NETWORK RAIL (CAMBRIDGE SOUTH INFRASTRUCTURE ENHANCEMENTS) ORDER

MAIN PROOF OF EVIDENCE ON MATTERS OF DRAINAGE

**PAUL JENKIN ON BEHALF OF
THE UNIVERSITY OF CAMBRIDGE**

Inquiry Document Reference	[TBC] /OBJ 8
Author	Paul Jenkin
Date	6 January 2022

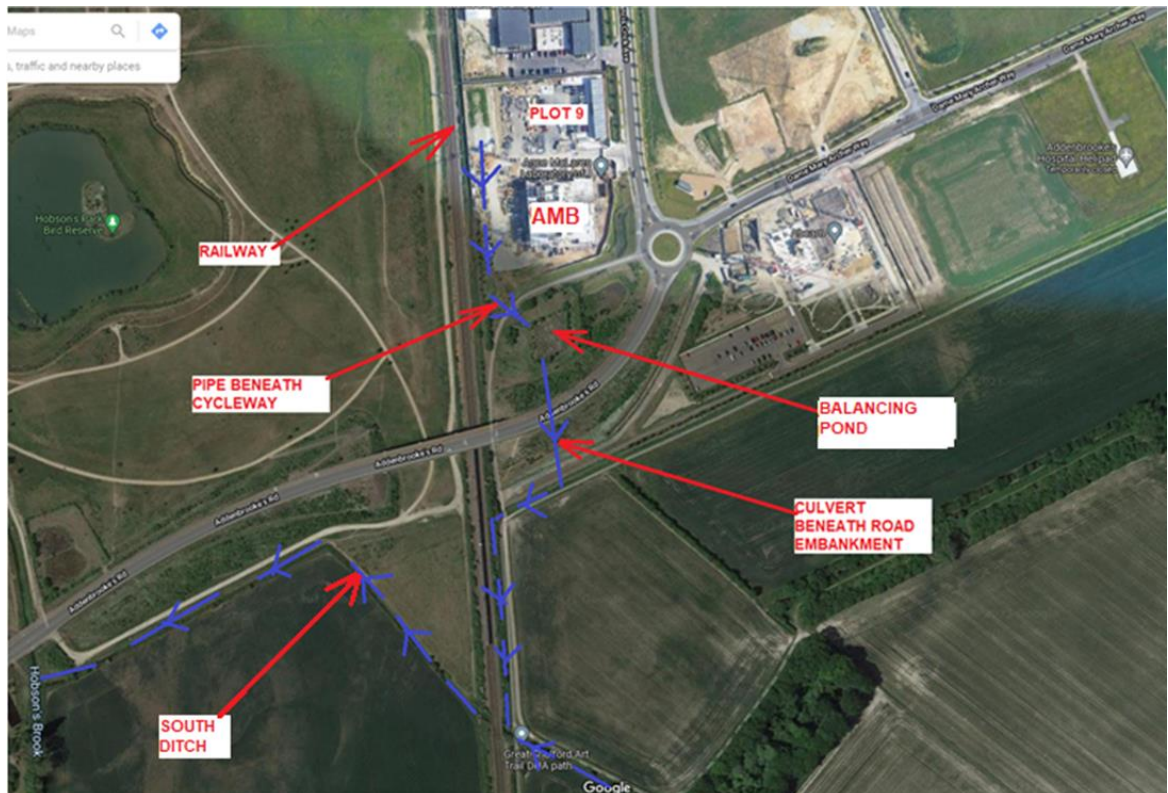
- 3.1 In the figure below the blue arrows indicate the route of surface water drainage from AMB and Plot 9. Both drain to the south between the existing railway and the existing and proposed buildings via a series of connected swales. Just upstream of the point marked as the “pipe beneath the cycleway” a hydrobrake is installed to limit the rate of flow from the two plots into the balancing pond highlighted on the plan. From the balancing pond flow is conveyed via a series of pipes and ditches and ultimately discharges into the Hobson’s Conduit in the south west corner of the figure below.
